## **Town of Groveland**

## **MEETING NOTICE**

TUESDAY, April 23, 2024

<u>CONTINUED 6-8 ELM PARK</u> – A public hearing in accordance with General Laws, Chapter 40A, as amended, for the application made by Rod Rivera, 97 Beach Street, Malden, for the premises located at 6-8 Elm Park Groveland, Map 10 Lot 013, located in the Business (B) Zoning District for a Special Permit for a Parking Reduction in accordance with Section 50-9.4 and Section 50-14.6 of the Groveland Zoning Bylaw due to an increase in parking for the operation of a restaurant.

## RE: TEC/Town Planner Perspective on Grass to Rip-Rap Change at 833 Salem Street/Groveland Self-Storage

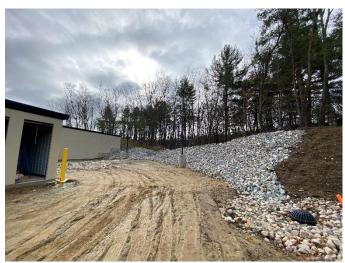
Below you can see photos that show where rip-rap was installed rather than grass, which was on the approved plan.

I asked TEC if they believed this would impact stormwater calculations for the site and they responded that the applicant should provide updated calculations to show that this change wouldn't negatively impact the stormwater of the site. The applicants engineer responded with the following...

"Annie, I was on-site Wednesday of last week for a full inspection of the site conditions but also looked at these areas TEC has noted. Although these areas were shown on the project plans as grassed or grassed with a retaining wall, it's my opinion that they still meet the intent of the stormwater analysis. In practice, I always model riprap areas (slopes, riprap aprons, forebay lining, etc.) as "open space - grass" in HydroCAD. I've only run into one project where we modeled the riprap area as something other than open grass cover and it was a project with tens of thousands of square feet of riprap stabilized slopes. I look at this similar to proposing a clean, crushed stone surface that might be used on a site and is generally accepted as a porous surface and therefore doesn't count towards impervious cover (also like porous pavement). So, it's my opinion that this construction field change doesn't change the way in which our stormwater analysis models the site."

There was additional back and forth and as it did not appear that Jones & Beach (engineer for the applicant) and TEC were going to be able to come to a resolution, I am bringing it to the Board. TEC provided the following comment that brings into perspective some important considerations when making their decision.

To take it to an extreme...I don't think the Town wants to set a precedent of openly allowing rip rap and lawn to be interchangeable, without providing any notice to the Town staff or Planning Board. How would the Town feel if 833 Salem Street made the change for <u>all grass areas</u> to be rip rap?"

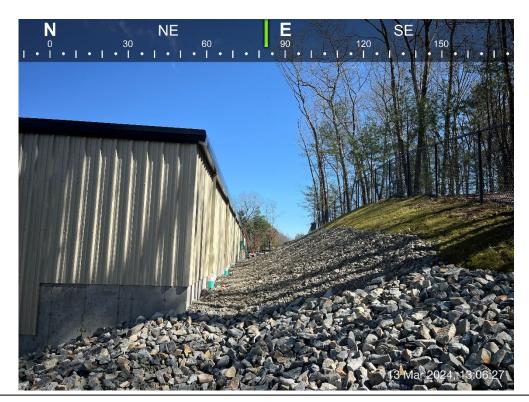
**Photo #9:** Large diameter riprap slope off southwest corner/side of Building #4. This area previously shown as grass slopes. During construction, uphill property currently under development by the abutter discharged large volumes of water towards the project site. This volume of water is not naturally occurring and resulted in washout of some vegetated slopes that had been established. This, combined with the developer's desire to ease slope maintenance, large diameter riprap stone was placed and we find this comparable to a vegetated surface.
